DARLING
HARBOUR LIVE
THE SOUTHERN
PRECINCT
SUPPLEMENTARY
DESIGN REPORT
FOR SSDA5

February 2014

This report has been prepared by Denton Corker Marshall in response to the DoPI letter dated 28 November 2013 and addendum. It also addresses the relevant issues raised by the City of Sydney submission to SSDA5. It provides additional clarification and/or response to particular design issues. A full assessment against all of the conditions in Stage 1 DA approval has been prepared as a separate Appendix to the response to submissions.

Updated SW1 Design - Darling Drive view looking north

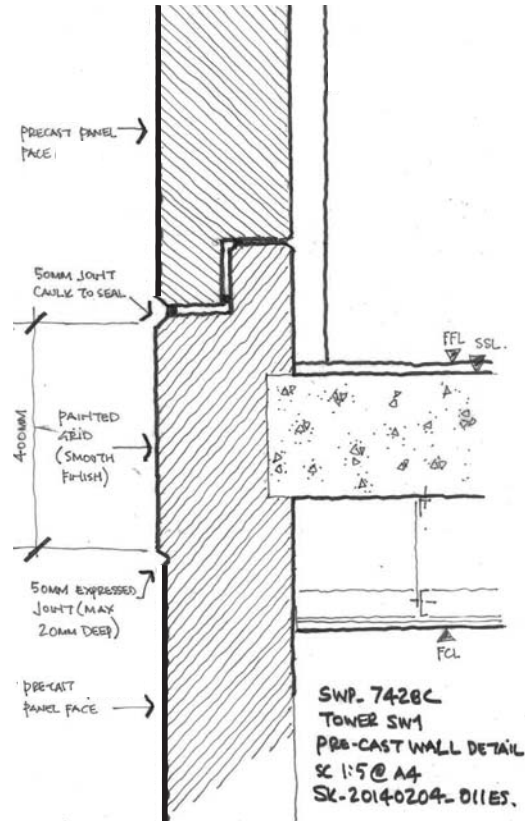
In the interest of achieving architectural excellence, the Department requires further consideration of the approach to the overall architectural treatment and articulation of tower SW1. The Department is concerned that the form and rigorosity of the gridded facade treatment coupled with the upper termination of the tower contrasts poorly with the architecture of the other elements of the SW Plot and would be visually dominant within the surrounding area.

In response to the DoPI concerns a number of modifications have been made to SW1. The projecting bay has been reconsidered and design improvements have been added to the west elevation to improve articulation and architectural excellence. The plant room has been lowered to a single storey and the grid expression has been accentuated. In addition, a response has been provided with respect to the window expression.

In response to the department's concerns, the grid is reinterpreted and this bay is broken down into a series of cubes stacked atop one another.

A projecting square cowl, as an extrusion of the ordering grid, creates shadows and introduces an element of contrast defining each cube.

The infill elevation repeats the typical facade treatment to integrate the cubes and avoid creating too alien an addition on the elevation.

Between each cube a slightly recessive and dark coloured floor enhances the perception of these cubes projecting out from the tower and breaks down the verticality of the bay.

Similarly, the rooftop plant enclosure is simplified and expressed as another cube sitting on the roof (refer to page 11). This roof enclosure has been reduced in height by 2.55m.

SW1 Tower with projecting apartment bay- Proposed amended design

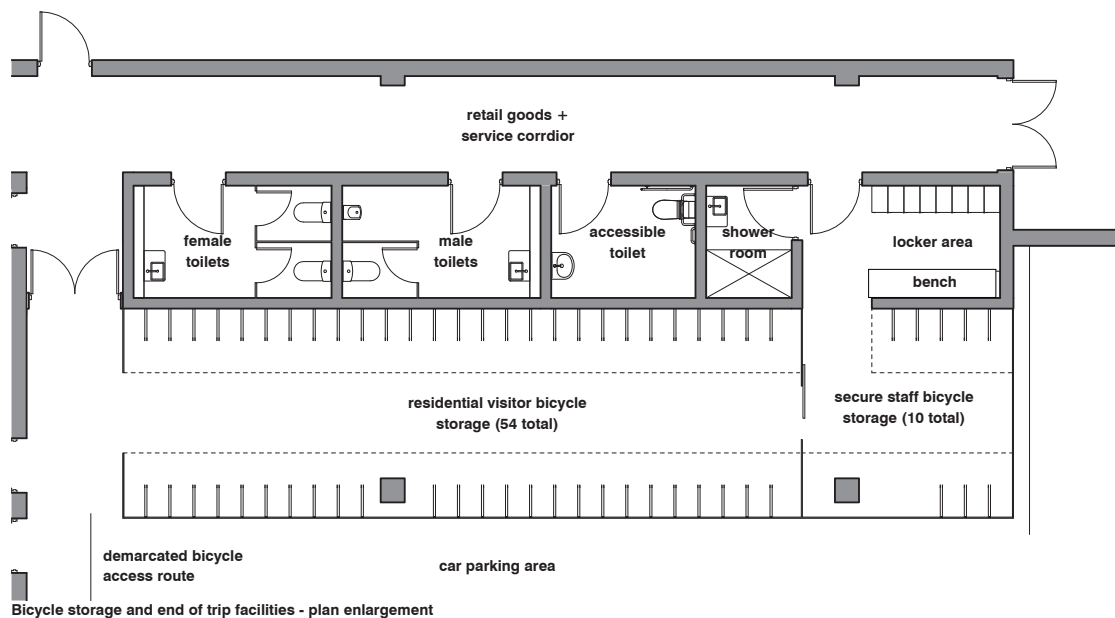
The Department considers that the cantilevered projecting bay should be removed and notes Council's concern in this regard

As noted within the Design Report submitted for SSDA5 the provision of an apartment bay on the western face of SW1 tower has positive urban design/architectural benefits:

- By projecting the apartment by 2.4 metres – the equivalent of a balcony zone – instead of setting the tower back flush the minimum separation between towers SW1 and SW3 is maintained;

- The projecting bay sits wholly within the approved parameter envelope that provides for a bay of this nature.
- The projecting bay has been designed so that it does not have an overbearing presence on Darling Drive.

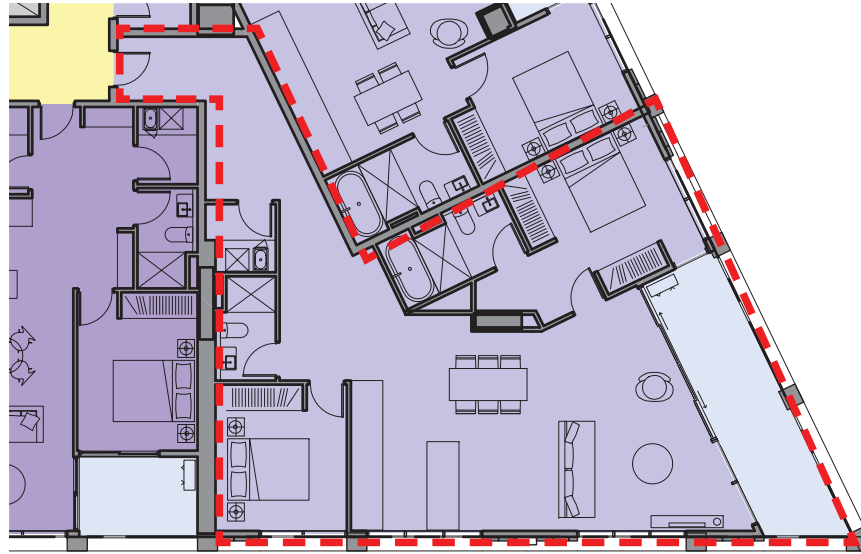
Clarification of end of trip facilities for cyclists is required.

As noted in the Design Report for SSDA5 allowance has been made to store resident's bicycles within each of the residential storage cages located in the car park.

- 54 undercover bicycle storage spaces for residential visitors (equivalent to 10% of total apartments);
- 10 secure, undercover bicycle storage spaces for staff working within the SW Plot;
- End of trip facilities for staff within the SW Plot which includes: a unisex shower; access to 2 male, 2 female and an accessible toilet (shared with retail unit patrons); 16 storage lockers; and
- Access via the vehicle entry point along a demarcated route.

Refer to sketch adjacent for location and layout of bicycle storage areas and end of trip facilities.

Extract from Amended SK_044 showing 3 Bed unit (outlined in red).

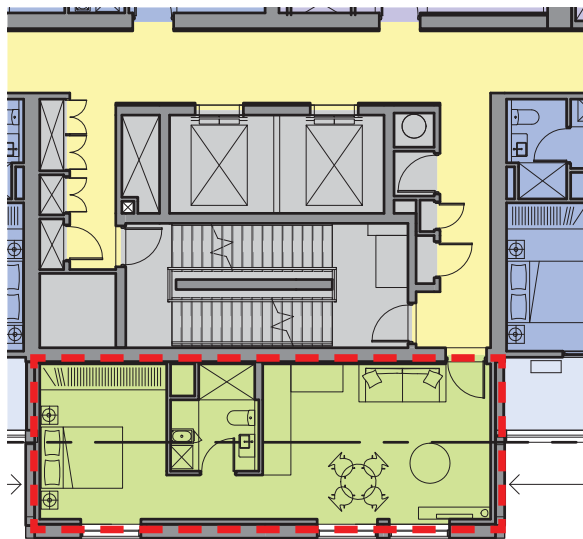
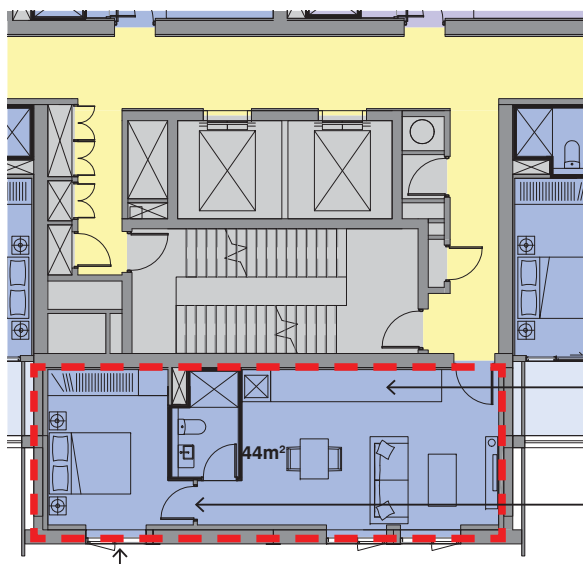
Further justification is required for the proposed mix of residential dwellings and the lack of larger 3 bedroom apartments.

- The number of 3 Bed units has been increased by 7 to 22 total. The additional 3 Bed units have been added to the podium levels increasing the product diversity of the development (refer to adjacent diagrams).
- The design of the 19 studios on the western elevation of SW1 have been reconsidered and improved. The product is now considered to be more aligned with the 1 Bed product in terms of the amenity afforded to residents. These have therefore been re-classified as 1 Bed (refer to pg.17).
- In addition, further product diversity is afforded by the provision of 10 apartments nominated as adaptable. The adaptable apartments will include a mix of 1 Bed and 2 Bed apartments and each will be allocated an accessible car space.

The layout of these apartments are considered to have appropriate amenity and size for a 1 Bed unit:

Visual separation of tower + podium - 're-entrant'

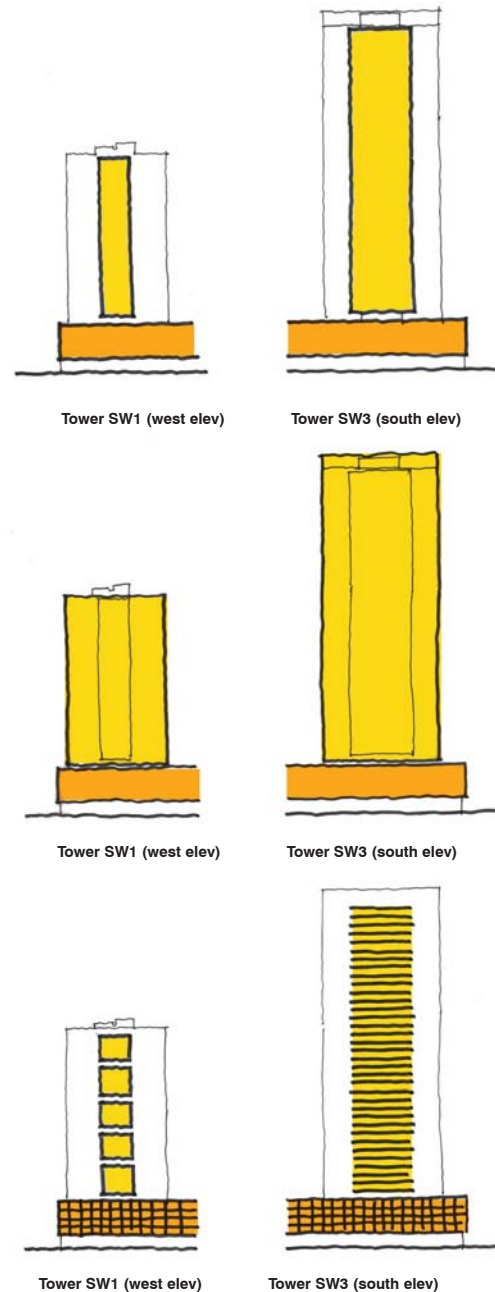
Future Development Applications shall demonstrate that the architectural feature(s) separating the residential towers from the street wall shall be appropriately designed to ensure that suitable visual separation between the two elements is achieved. Furthermore, contrasting materials or other acceptable alternatives shall be used to give emphasis/visual primacy to the lower levels of the buildings (below the re-entrant feature).

As noted in the SSDA2 Design Guidelines a re-entrant was proposed to ensure a distinction between the form of the towers and the 'street wall' of the urban block (podium).

This was presented to the DRP to clarify the approach adopted on each tower, and it was agreed that the design addressed the visual and physical separation contemplated in SSDA2 guidelines.

The images opposite (noting SW1 west elevation has now been updated) were presented to the DRP. The highlighted boxes clearly showing the tower expression commencing a storey above the podium street wall.

Street activation diagram

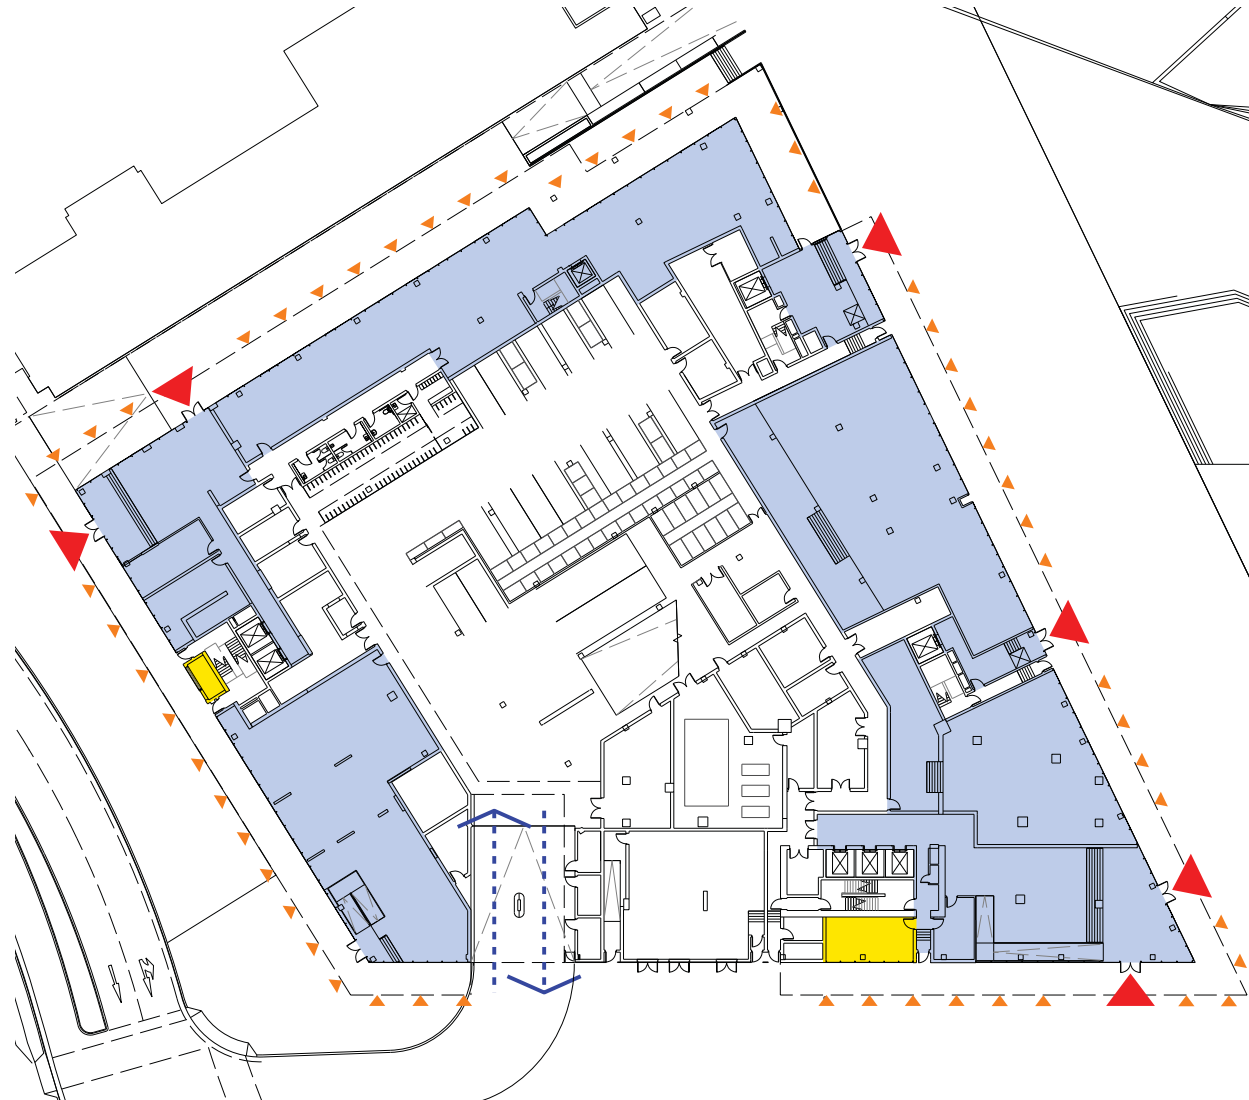
Future Development Applications shall maximise street level activation where possible. A Street Level Activation Plan shall be provided that:

CoS concerns recognising Hay Street as a new key connection from the west and to support a positive urban design outcome and active ground plane along this street is supported. The design team propose:

Refer to diagram adjacent indicating extents of occupied space and activation at ground level

- Increase activated frontage on Hay Street by locating new IQ hub (Potential)/ retail in lieu of services plant south of SW3 core; and
- Increased activated frontage on Darling Drive by locating new active uses north of SW1 core.

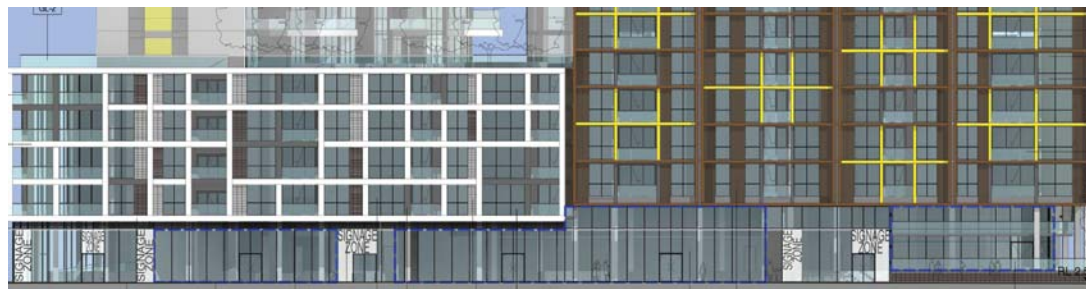
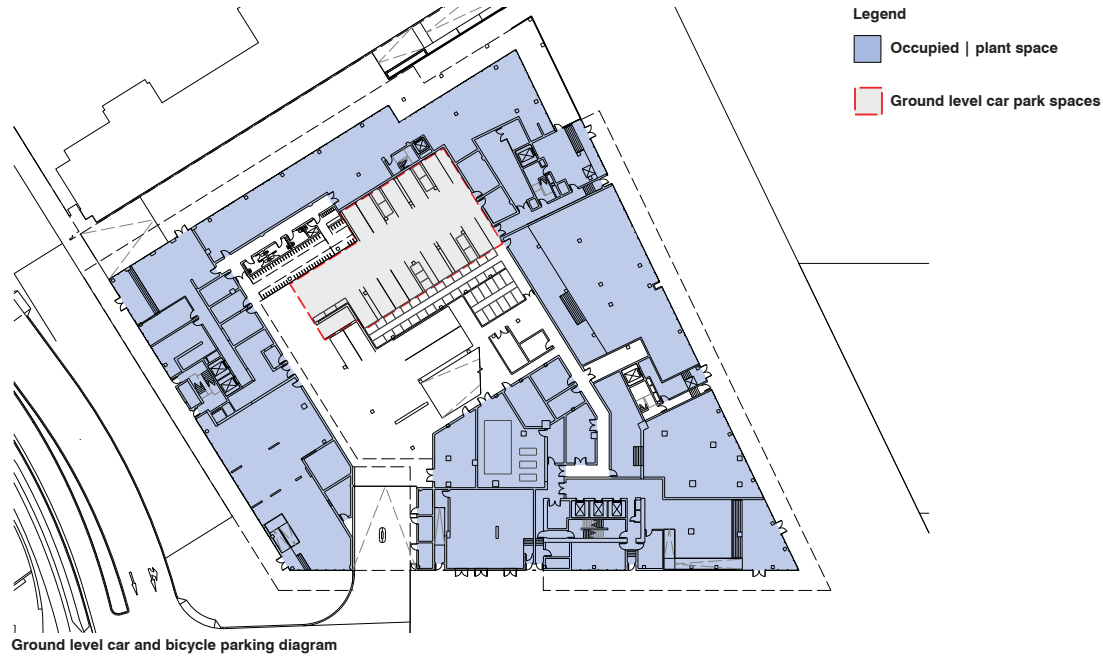
Future Development Applications shall demonstrate that appropriate pedestrian sightlines/visual safety is achieved at building corner locations. Mitigation measures may include (but are not limited to) providing glazing to the corners of retail shop fronts and residential/ commercial lobbies.

- All four building corners are fully glazed, with residential lobbies located on two of these corners;
- Proposed residential lobbies overlook other entry lobbies within the development;
- A diverse programme of active uses are proposed around the building perimeter at ground level – refer DoPI Planning Condition B3 response for more detail;
- The recessed terrace on the corner of Dickson's Lane and The Boulevard is on a raised plinth, behind a continuous glazed balustrade which avoids a colonnade along the Boulevard and enables clear visibility around the corner;
- Re-entrant escape doorways are located adjacent residential lobbies and retail frontages;
- The building vehicle entry point has an operable roller shutter which will be closed outside of normal business hours; and
- Generous pedestrian pavements and quality street lighting ensure a safe and welcoming environment.

Refer to the marked up elevations below indicating the ground level uses.

SW Plot car park access options

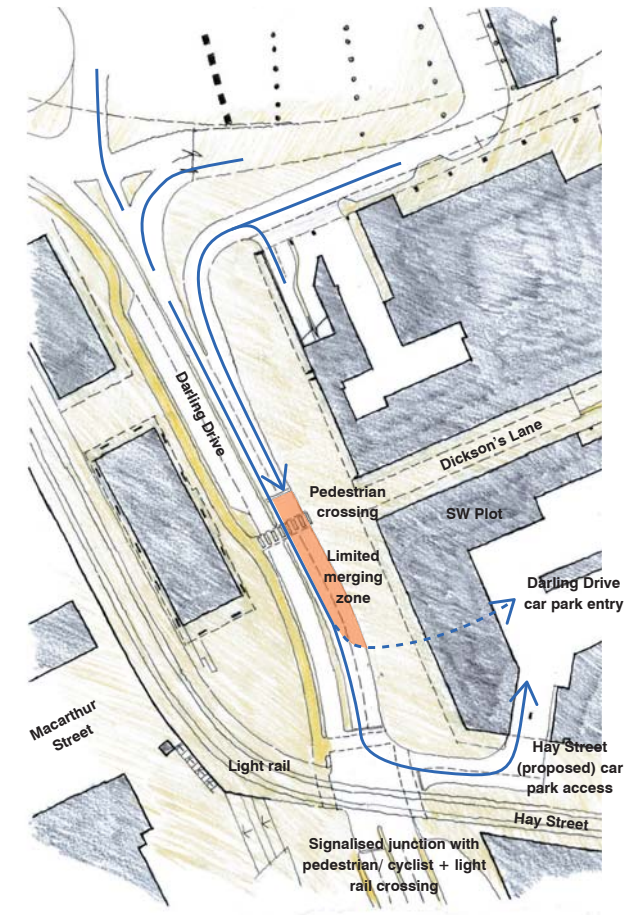
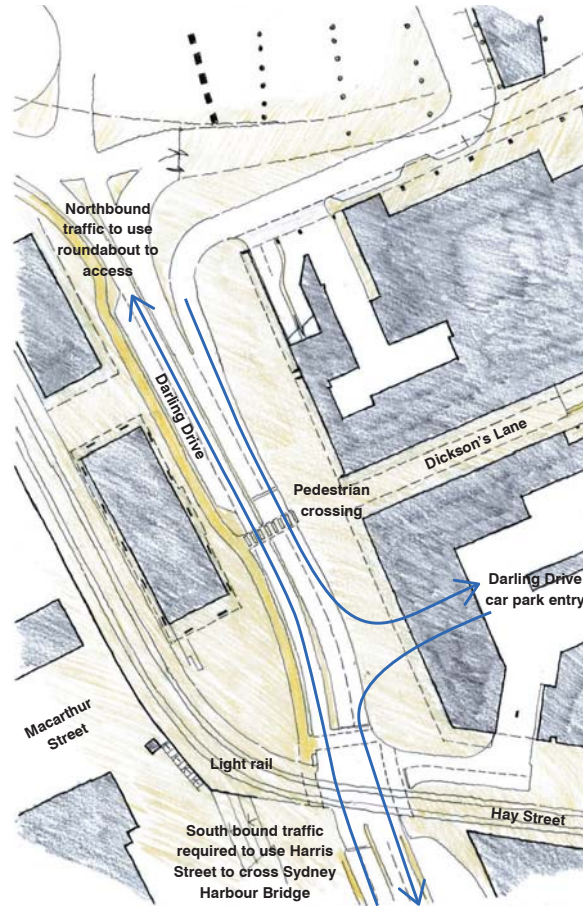
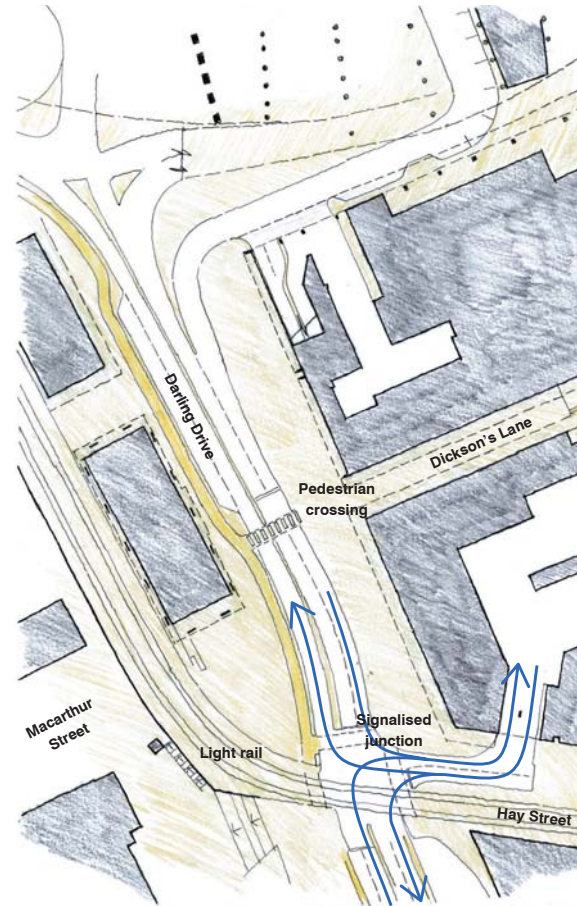
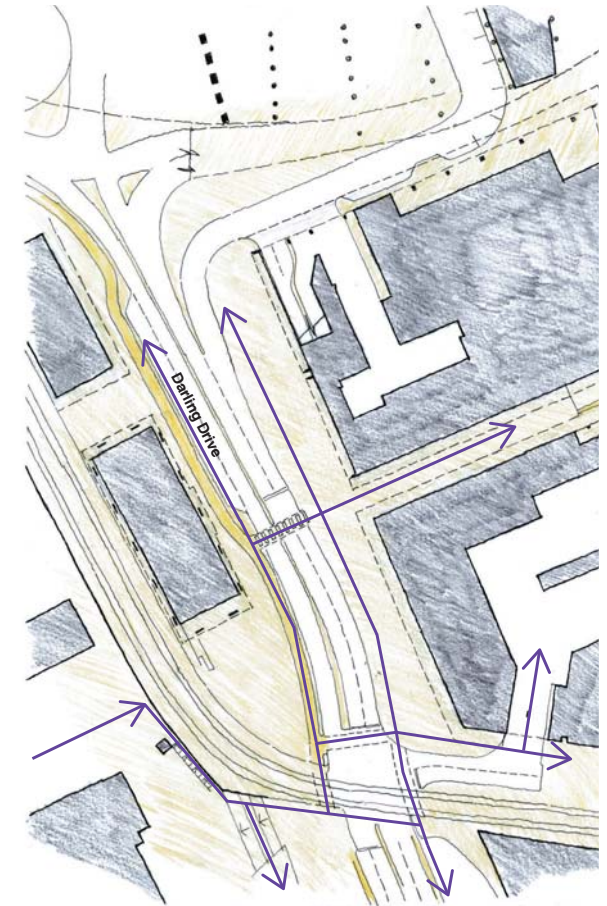
"Provide further activation along Hay Street by a reconfiguration of the IQ Hub, or other activating use. Plant and services located on the Hay Street frontage should be relocated."

The location of the vehicle entry point on Hay Street has been informed by a number of local context and site specific issues:

- DRP + CoS comments in relation to the provision of a visible, active frontage at the terminus of Macarthur Street/ Goods Line adjacent the proposed new Macarthur Place;
- The existing vehicle entry point for the SEC car park is located on Hay St and is accessed from Darling Drive via a signalised intersection;
- The proposed arrangement mimics the existing layout and has the advantage of utilising the existing intersection signal controls;
- The vehicle access on Hay Street allows traffic to be managed at the existing signalised junction and consolidates all pedestrian, cyclist, traffic and light rail crossing movements at the Hay Street/ Darling Drive junction;
- Accessibility to and from the SW Plot car park is enhanced since it allows access to both northbound and southbound travel;

- Split the potential IQ Hub tenancy and create a poor urban design outcome on this key corner;
- Be limited to a left-in-left-out arrangement due to its proximity to the Hay Street and Pier Street intersections. This would require all northbound traffic to use the roundabout at Pier Street adding to the traffic numbers on the roundabout;
- Pose an added safety risk with vehicles travelling on the southbound through lane and intending to turn left at the car park entrance. There could be weaving conflicts between vehicles egressing the Exhibition Loop Road and vehicles on the through lane from the Pier Street roundabout;
- Create greater safety risks due to the proximity of the proposed pedestrian crossing (from Macarthur Place) to the vehicle entry on Darling Drive would.

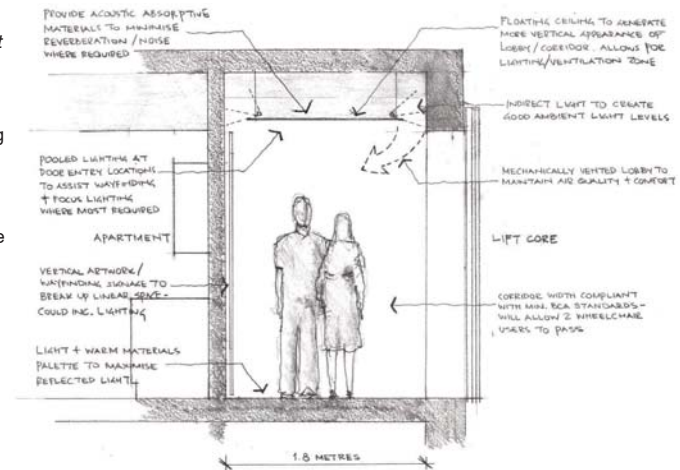
"Provide natural light and the potential for natural ventilation to the lift lobbies and corridors."

The design of the towers for SSDA 5 is for a central core maximising the apartment perimeter to achieve the development benchmarks set within the RFDC for orientation and aspect, access to daylight and natural ventilation.

- An 1800mm wide passage, comfortably wide for two people to pass including two wheelchair users;
- The lobbies and corridors will be designed to achieve generous proportion and ensure adequate space for furniture movements;
- Good lighting – including indirect lighting around the lobbies – will provide a pleasant experience;
- Mechanical and fresh air supply will improve air quality and comfort;
- No dead ends or blind corners within corridors and the number of apartments opening off a single lobby has been limited to a maximum of nine (9); and
- All mechanical and electrical fittings will be low energy to minimise building energy use. Photo-voltaic panels are proposed at roof level to offset energy use within the building.
